Does 1166L
BNSF Need Plans?
~~Hal Industrial~~ Barnett Industrial
BNSF Conflict Sta 16620+00 WL

~~SECRET~~
BNSF Conflict No. 27 & 28

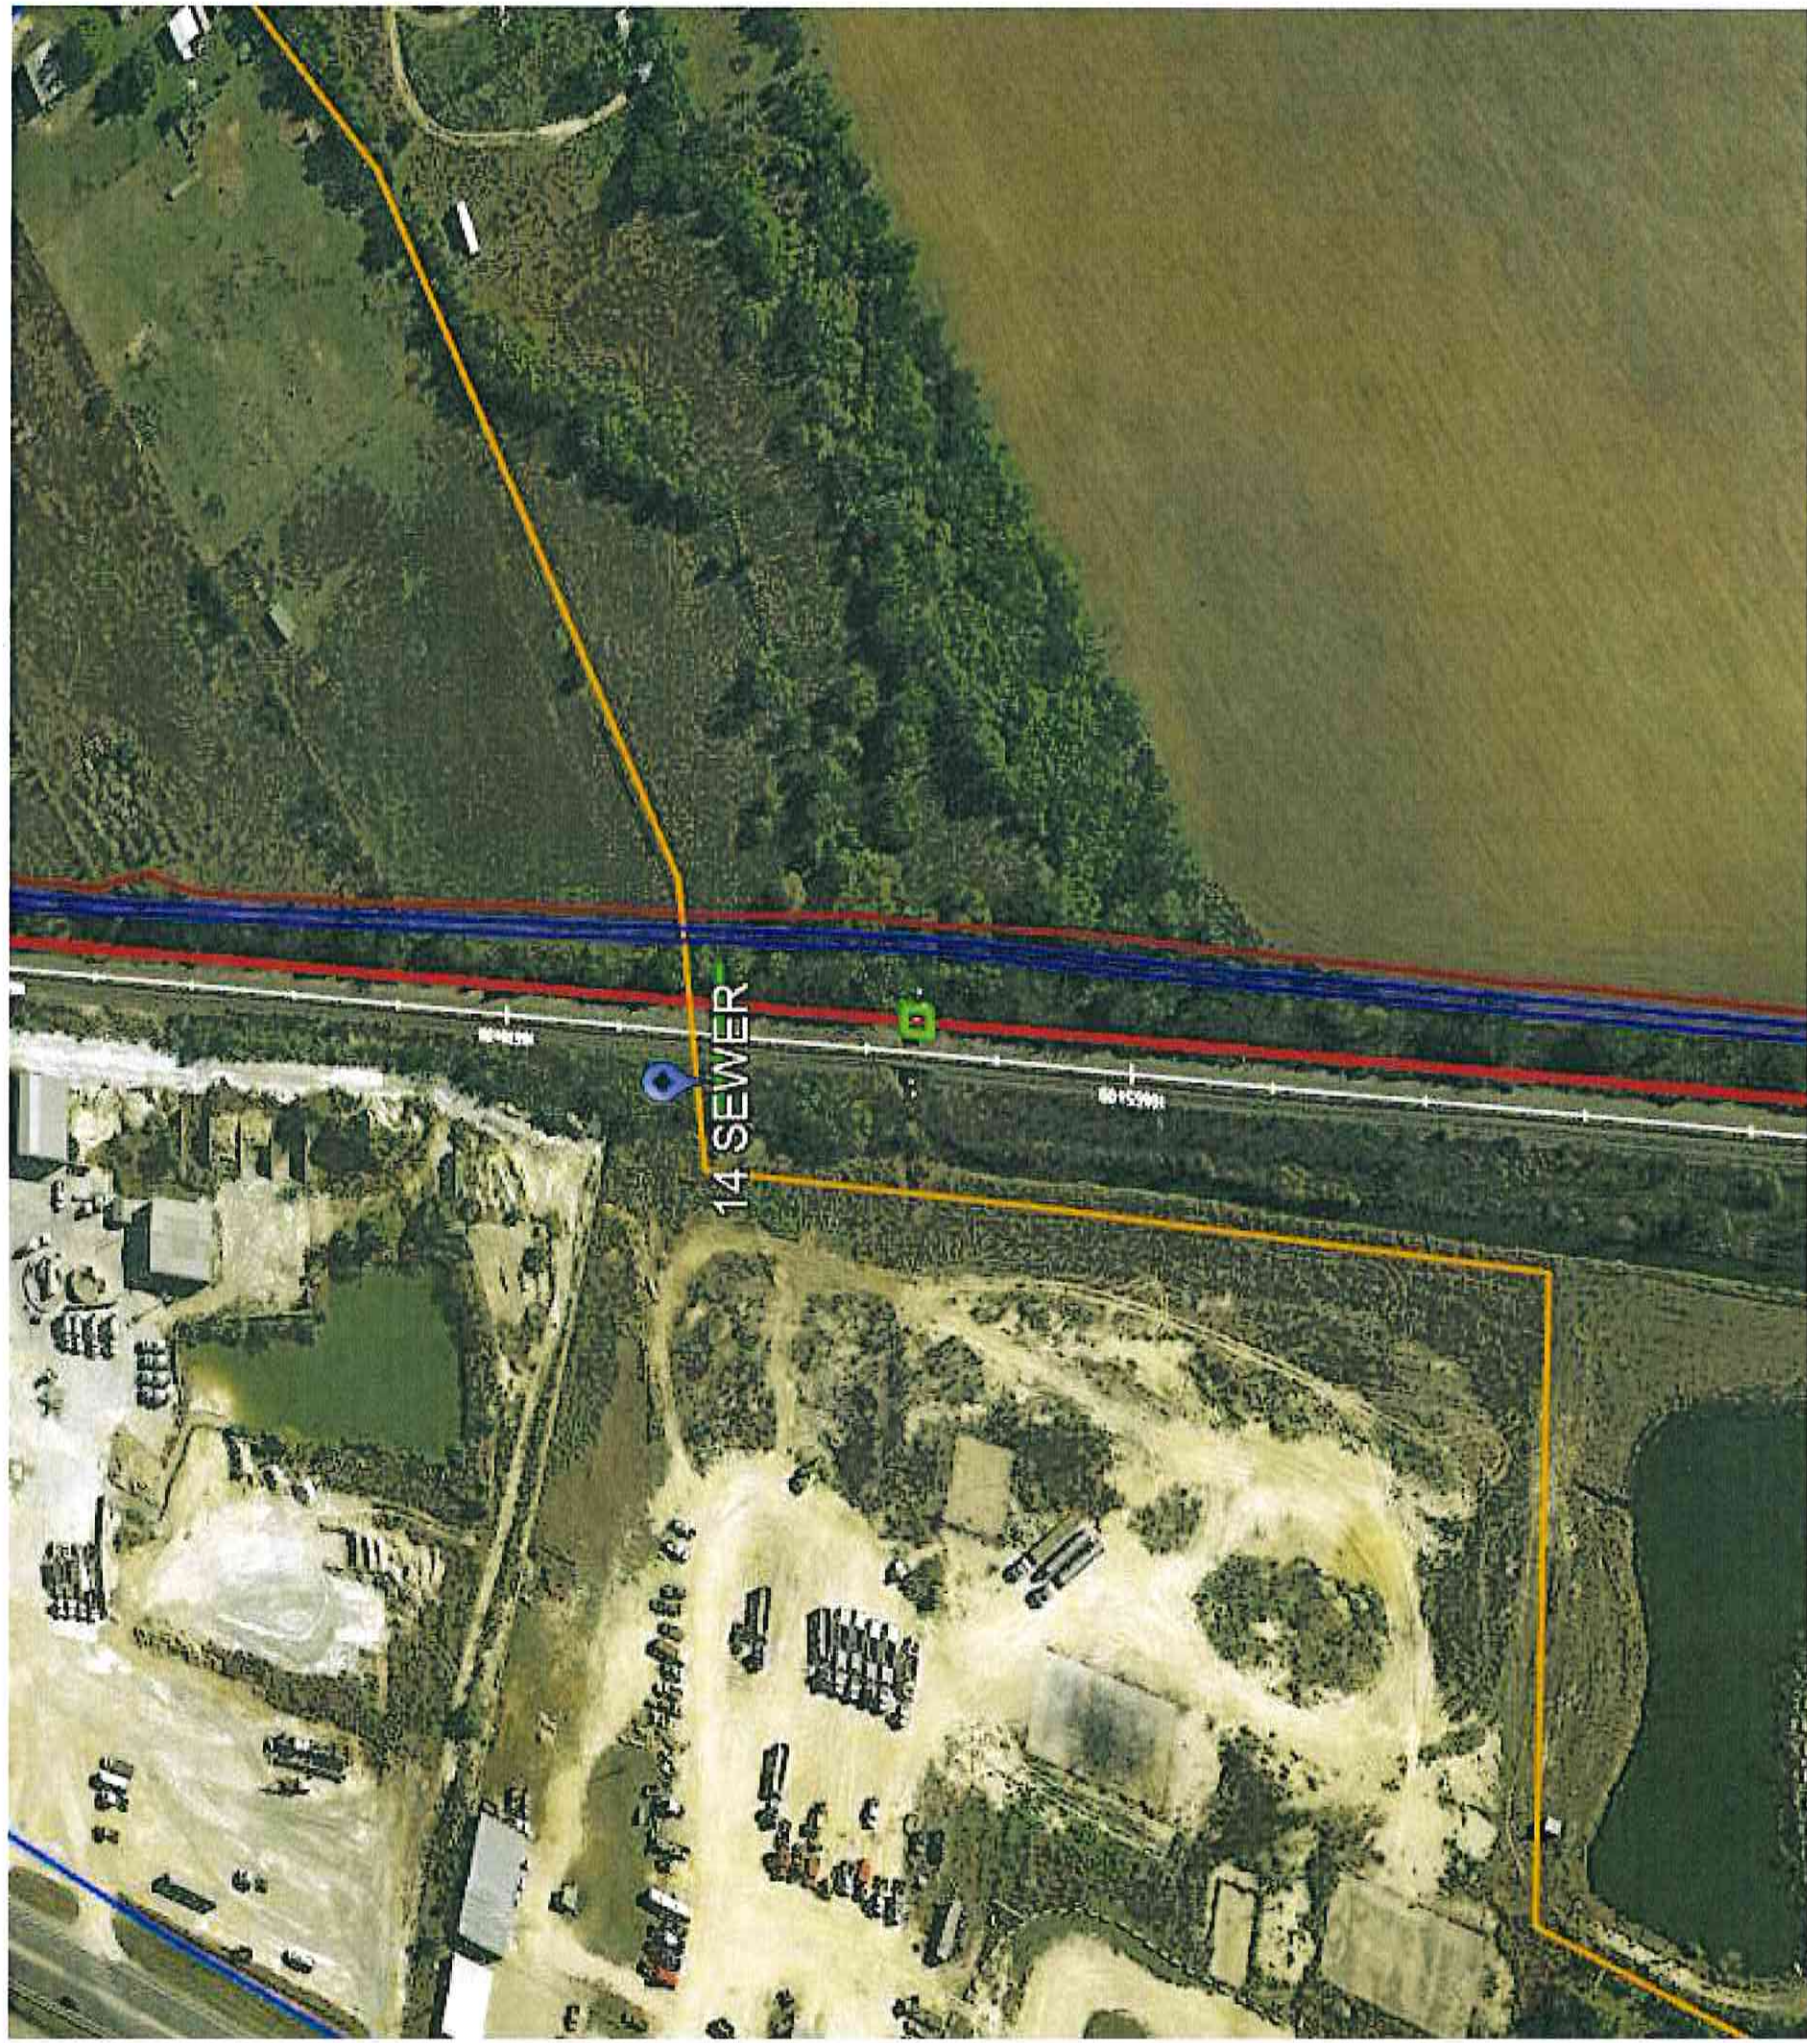
- Exhibit 14 - plan set - alignment correct
- not shown on city GIS

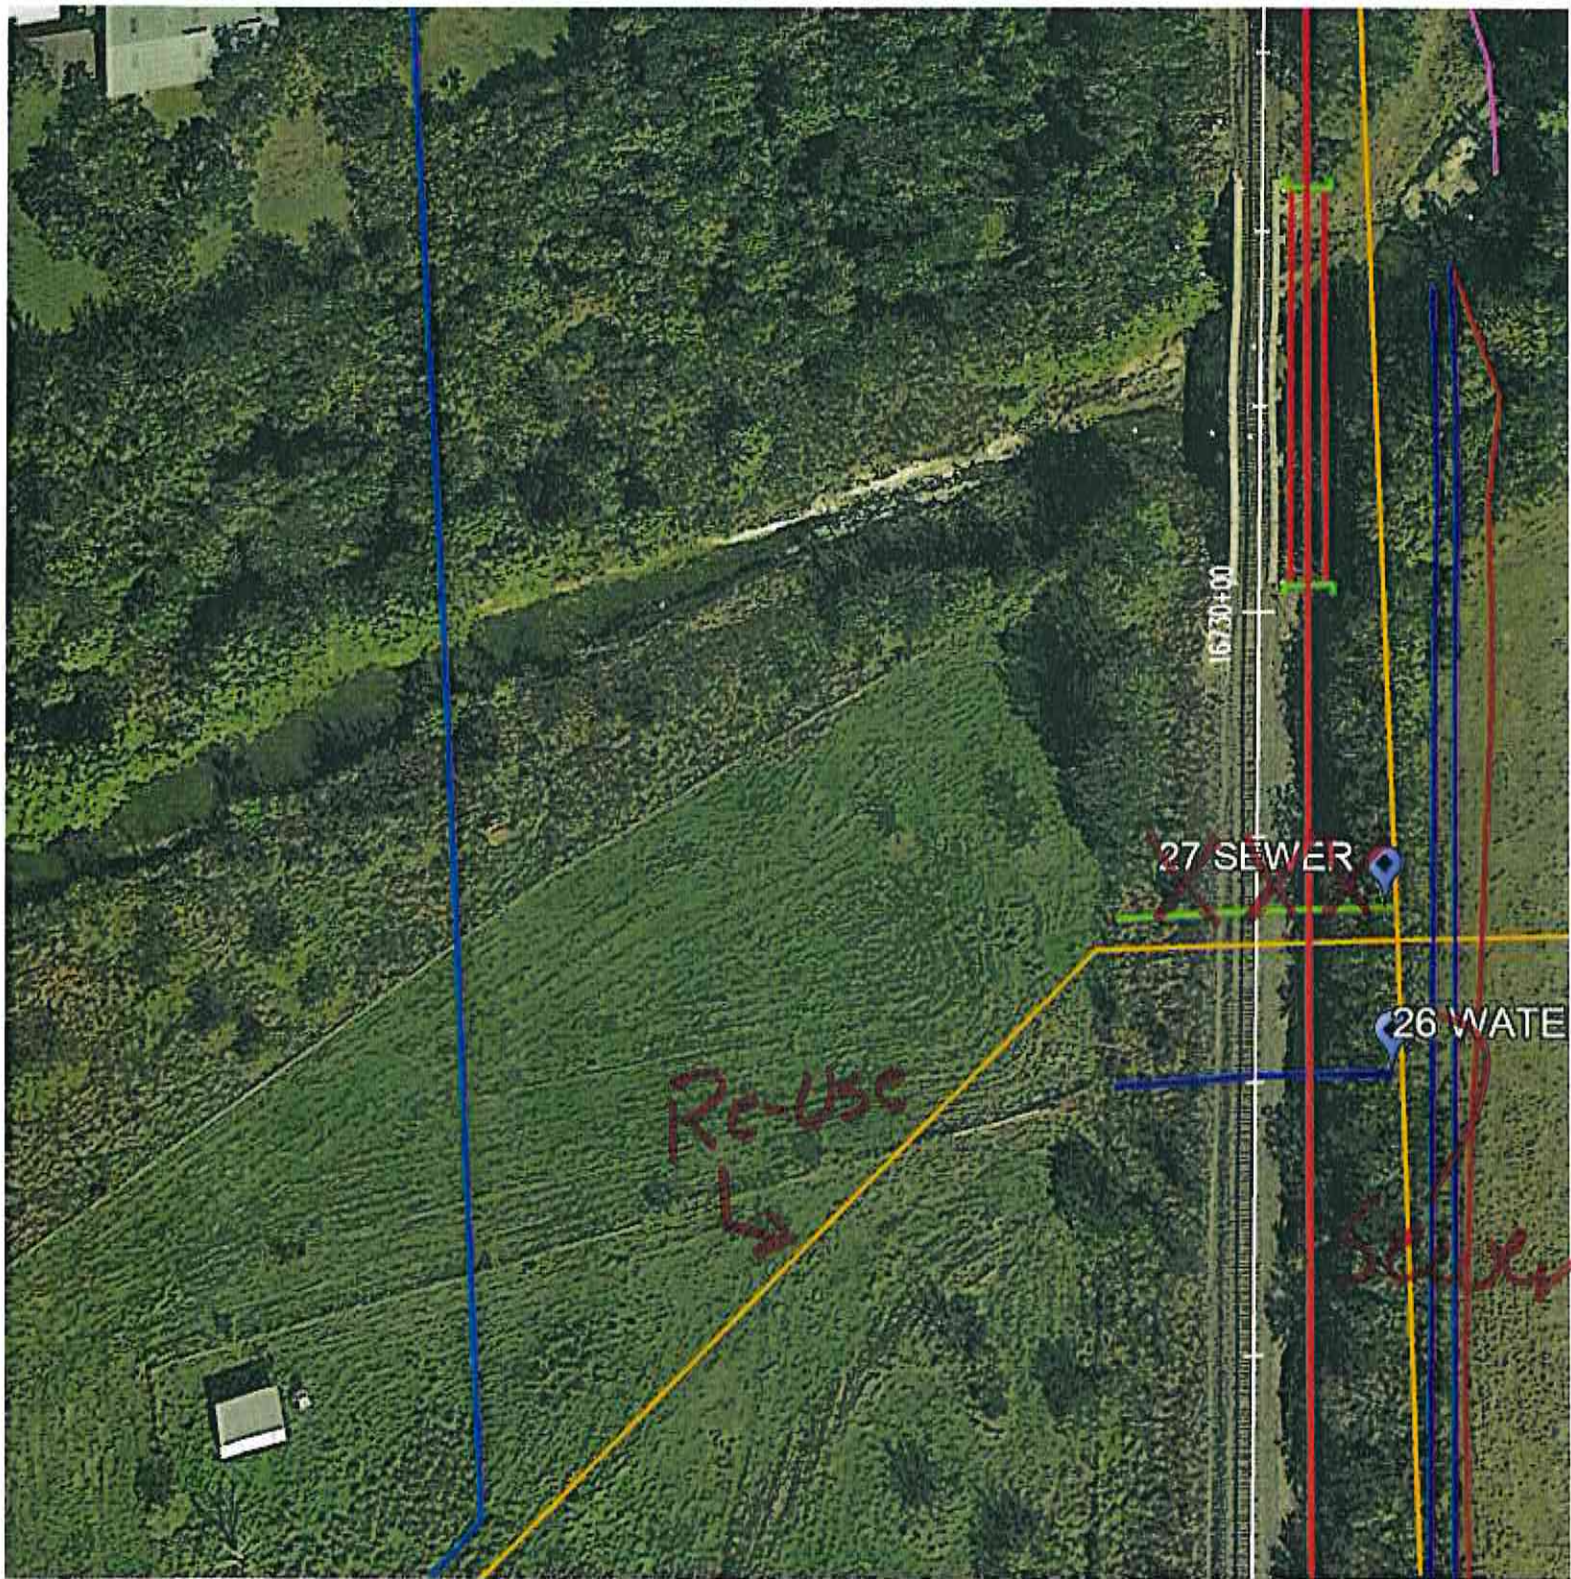
- Exist ReUse Line U-16
(Exhibit 27)
 - SWR line in location of conflict 26
 - No line @ Conflict 27
- Conflict 27
